Endangered and Threatened Wildlife; Sea Turtle Conservation Requirements

ACTION: Final rule.

SUMMARY: NMFS is amending the turtle excluder device (TED) regulations that require most shrimp trawlers to use Turtle Excluder Devices (TEDs) in the southeastern Atlantic and the Gulf of Mexico, to reduce the incidental capture of endangered and threatened sea turtles during shrimp trawling. Specifically, NMFS is allowing the use of a design of

Figure 1. Illustration of offshore hooped hard TED dimensions, showing optional water deflector fin.

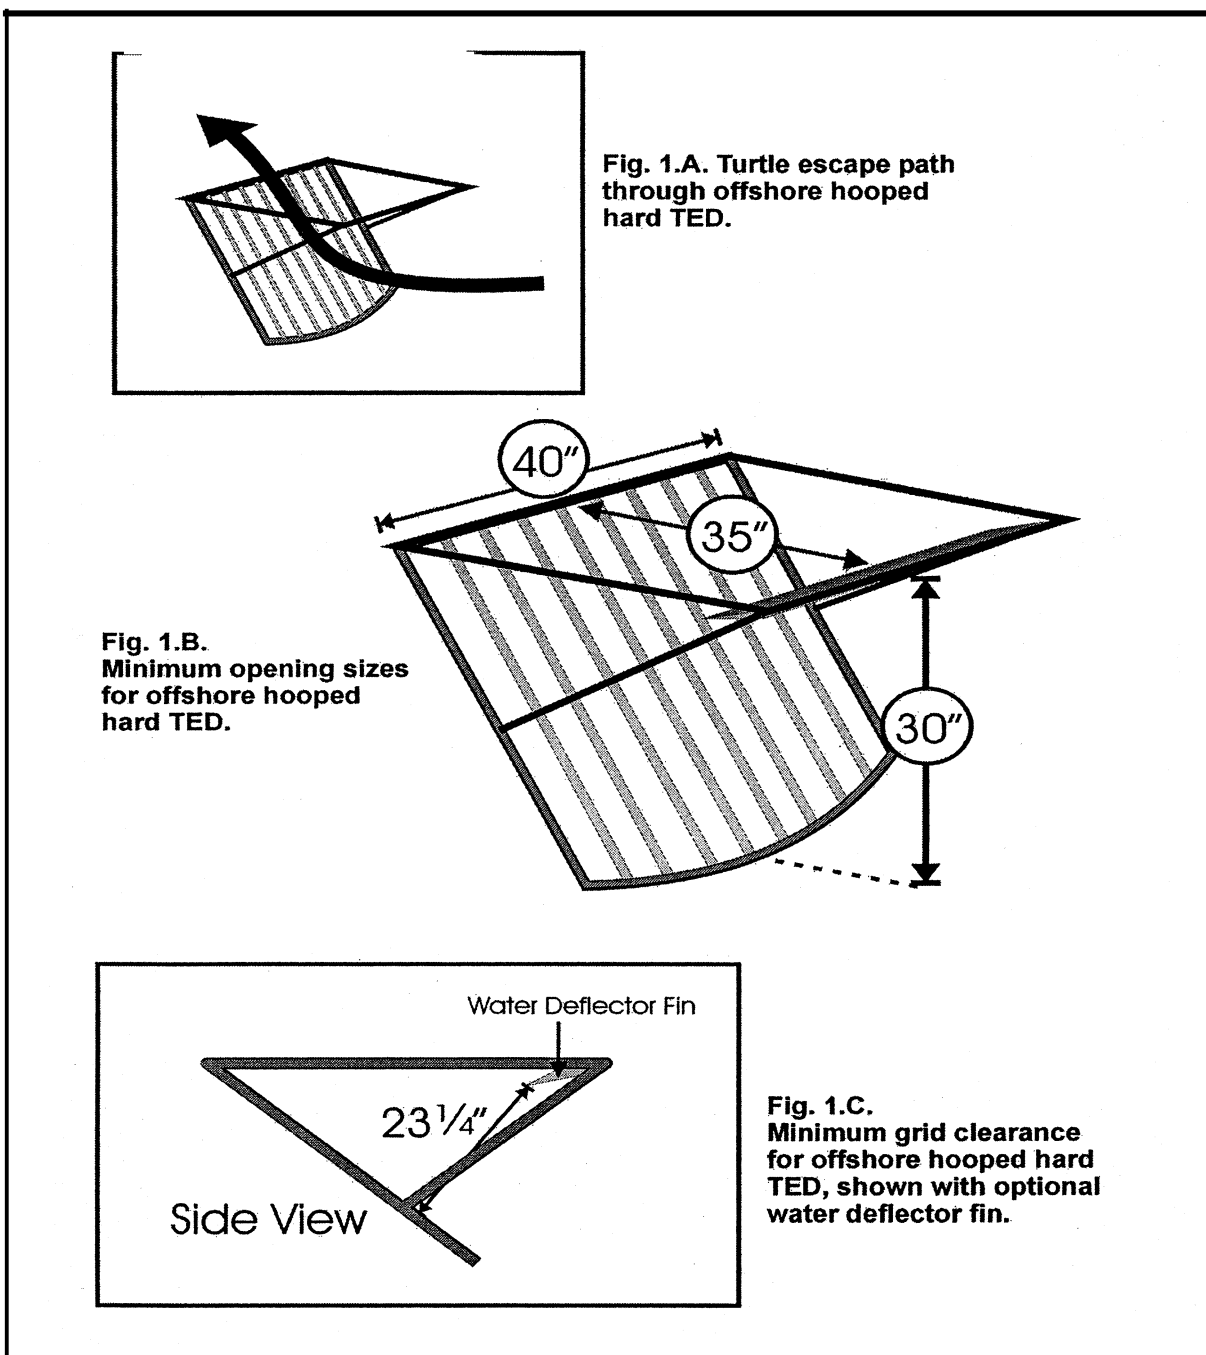
has to meet certain minimum construction standards, in addition to the construction standards specified for hard TEDs generally. The frame for this TED must be made of aluminum rod with a minimum outside diameter of 5/8 inch (1.59 cm) or aluminum tubing with a minimum outside diameter of 1 inch (2.54 cm) and a minimum wall thickness of 1/8 inch (0.32 cm). The escape opening must have a horizontal measurement of no less than 40 inches (102 cm) wide and a forward measurement of no less than 35 inches (89 cm). The front hoop on an offshore hooped hard TED must have an inside horizontal measurement of at least 40 inches (102 cm) and an inside vertical measurement of at least 30 inches (76 cm). The minimum clearance between the deflector bars and the forward edge of the escape opening must be at least 23 1/4 inches (59 cm). The measurement between support bars must be no less than 40 inches (102 cm) (see Figure 1 for illustrations of the offshore hooped hard TED and its dimensions)

This final rule will also allow three modifications for hooped hard TEDs. The first is the use of a water deflector fin used to increase shrimp retention. The original Coulon TED design incorporates such a water deflector fin. This fin can be welded onto the forward edge of the escape opening, projecting aft into the TED with an angle of 5 to 45-degrees from the normal, horizontal plane of the trawl. The fin must be constructed of a flat aluminum bar, up to 3/8 inch (0.95 cm) thick and up to 4 inches (10.2 cm) deep. The fin may be as wide as the width of the escape opening, minus 1 inch (2.5 cm).

(ii) *Offshore hooped hard TED.* An offshore hooped hard TED must be constructed of aluminum, with minimum dimensions as follows:

(A) Solid rod with a minimum outside diameter of 5/8 inch (1.59 cm); or

(B) Tubing with a minimum outside diameter of 1 inch (2.54 cm) and a minimum wall thickness of 1/8 inch (0.32 cm).

(B) \ The offshore hooped hard TED escape opening must have a horizontal measurement of no less than 40 inches (102 cm) wide and a forward measurement of no less than 35 inches (89 cm). A hinged door frame may be used to partially cover the escape opening as provided in paragraph (d)(7) of this section. Alternatively, a webbing flap may be used as provided in paragraph (d)(3)(ii) of this section. The resultant escape opening with a webbing flap must have a stretched mesh circumference of no less than 142 inches (361 cm).

(B) *Offshore hooped hard TED.* The front hoop on an offshore hooped hard TED must have an inside horizontal measurement of at least 40 inches (102 cm) and an inside vertical measurement of at least 30 inches (76 cm). The minimum clearance between the deflector bars and the forward edge of the escape opening must be at least 23 1/4 inches (59 cm).

Figure 2. Hooped hard TED with optional hinged door frame and water deflector fin.

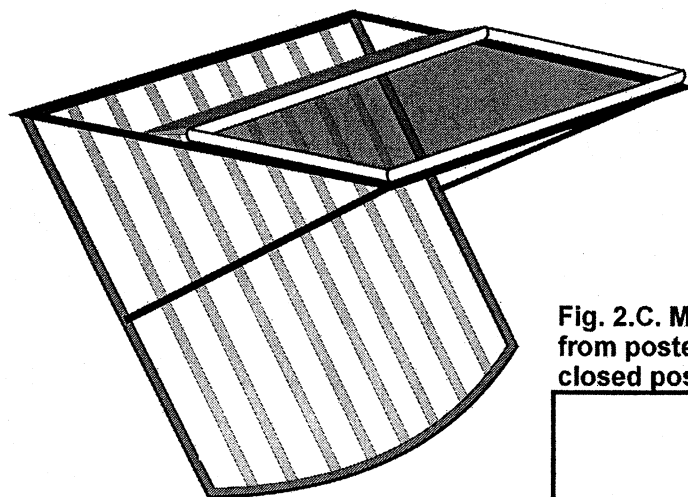
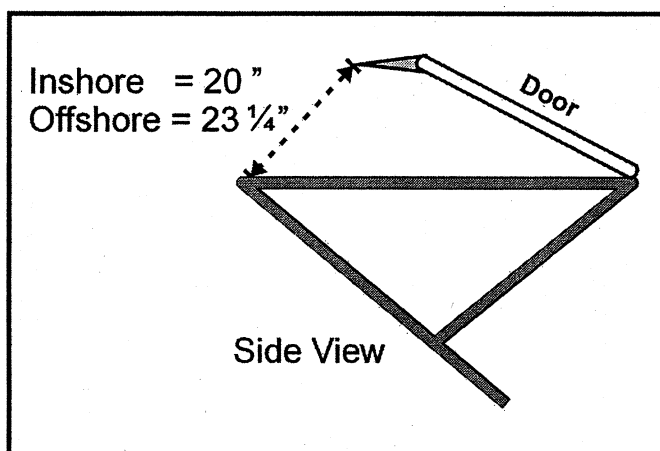
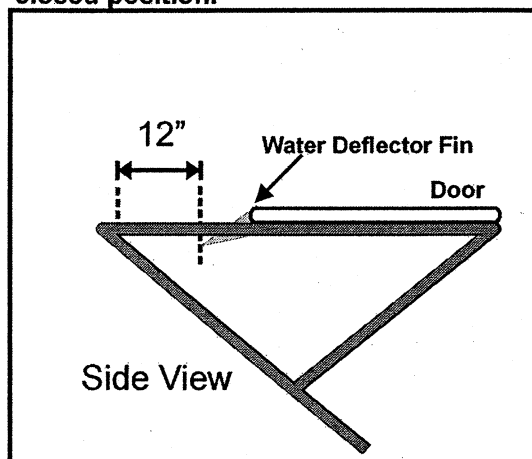
The third allowable modification for hooped hard TEDs is the use of a hinged

door frame to partially cover the escape opening. The door frame must be at least as wide as the escape opening, may be up to a maximum of 24 inches (61 cm) long, may be covered with taut mesh webbing (the size of the mesh cannot be greater than that used for the TED extension webbing), and must be connected to the forward edge of the escape opening by a hinge device that will allow the door to open upwards freely. The posterior edge of the door frame, in the closed position, must lie at least 12 inches (30 cm) forward of the posterior edge of the escape opening. If a water deflector fin is used with a hinged door it must be welded to the posterior edge of the door frame, projecting aft into the TED with an angle of 5–45 degrees from the normal, horizontal plane of the trawl. The fin must be constructed of a flat aluminum bar, up to 3/8 inch (0.95 cm) thick and up to four inches (10.2 cm) deep. The fin may be as wide as the width of the escape opening, minus one inch (2.5 cm). The deflector fin must be no less than 12 inches (30 cm) forward of the posterior edge of the escape opening, when the door is in the closed position. Two stopper ropes or a hinge limiter

may be used to limit the maximum opening height of the hinged door frame, as long as the minimum clearance between any part of the deflector bars and any part of the door, including a water deflector fin if installed, in its fully open position is at least 23 1/4 inches (59 cm) for an offshore hooped hard TED or at least 20 inches (51 cm) for an inshore hooped hard TED. The purpose of the stopper ropes or hinge limiters is to prevent the door frame from opening excessively during net deployment and haulback, possibly resulting in loss of catch or damage to the door. Any stopper ropes or hinge limiters must not restrict the free operation of the door, up to its maximum opening (i.e. the door must be able to easily swing to the required opening height before the stops or limiters affect its movement). The hinged door cannot be used in combination with a webbing flap or with a water deflector fin attached to the forward edge of the escape opening (See Figure 2 for illustration of the optional hinged door frame, shown with water deflector fin).

(6) *Water deflector fin for hooped hard TEDs.* On a hooped hard TED, a water deflector fin may be welded to the forward edge of the escape opening. The fin must be constructed of a flat aluminum bar, up to 3/8 inch (0.95 cm) thick and up to 4 inches (10.2 cm) deep. The fin may be as wide as the width of the escape opening, minus 1 inch (2.5 cm). The fin must project aft into the

TED with an angle between 5° and 45° from the normal, horizontal plane of the trawl. On an inshore hooped hard TED, the clearance between the deflector bars and the posterior edge of the deflector fin must be at least 20 inches (51 cm). On an offshore hooped hard TED, the clearance between the deflector bars and the posterior edge of the deflector fin must be at least 23–1/4 inches (59 cm).

(7) *Hinged door frame for hooped hard TEDs.* A hinged door frame may be attached to the forward edge of the escape opening on a hooped hard TED. The door frame must be constructed of materials specified at paragraphs (a)(1)(i) or (a)(1)(ii) of this section for inshore and offshore hooped hard TEDs, respectively. The door frame may be covered with a single panel of mesh webbing that is taut and securely attached with twine to the perimeter of the door frame, with a mesh size not greater than that used for the TED extension webbing. The door frame must be at least as wide as the TED escape opening. The door frame may be a maximum of 24 inches (61 cm) long. The door frame must be connected to the forward edge of the escape opening by a hinge device that allows the door to open outwards freely. The posterior edge of the door frame, in the closed position, must lie at least 12 inches (30 cm) forward of the posterior edge of the escape opening. A water deflector fin may be welded to the posterior edge of the hinged door frame. The fin must be constructed of a flat aluminum bar, up to 3/8 inch (0.95 cm) thick and up to four inches (10.2 cm) deep. The fin may be as wide as the width of the escape opening, minus one inch (2.5 cm). The fin must project aft into the TED with an angle between 5° and 45° from the normal, horizontal plane of the trawl, when the door is in the closed position. The clearance between the posterior edge of the escape opening and the posterior edge of the door frame or the posterior edge of the water deflector fin, if installed, must be no less than 12 inches (30 cm), when the door is in the closed position. Two stopper ropes or a hinge limiter may be used to limit the maximum opening height of the hinged door frame, as long as they do not obstruct the escape opening in any way or restrict the free movement of the door to its fully open position. When the door is in its fully open position, the minimum clearance between any part of the deflector bars and any part of the door, including a water deflector fin if installed, must be at least 20 inches (51 cm) for an inshore hooped hard TED and at least 23 1/4 inches (59 cm) for an offshore hooped hard TED. The hinged

door frame may not be used in combination with a webbing flap specified at paragraph (d)(3) of this section or with a water deflection fin specified at paragraph (d)(6) of this section.
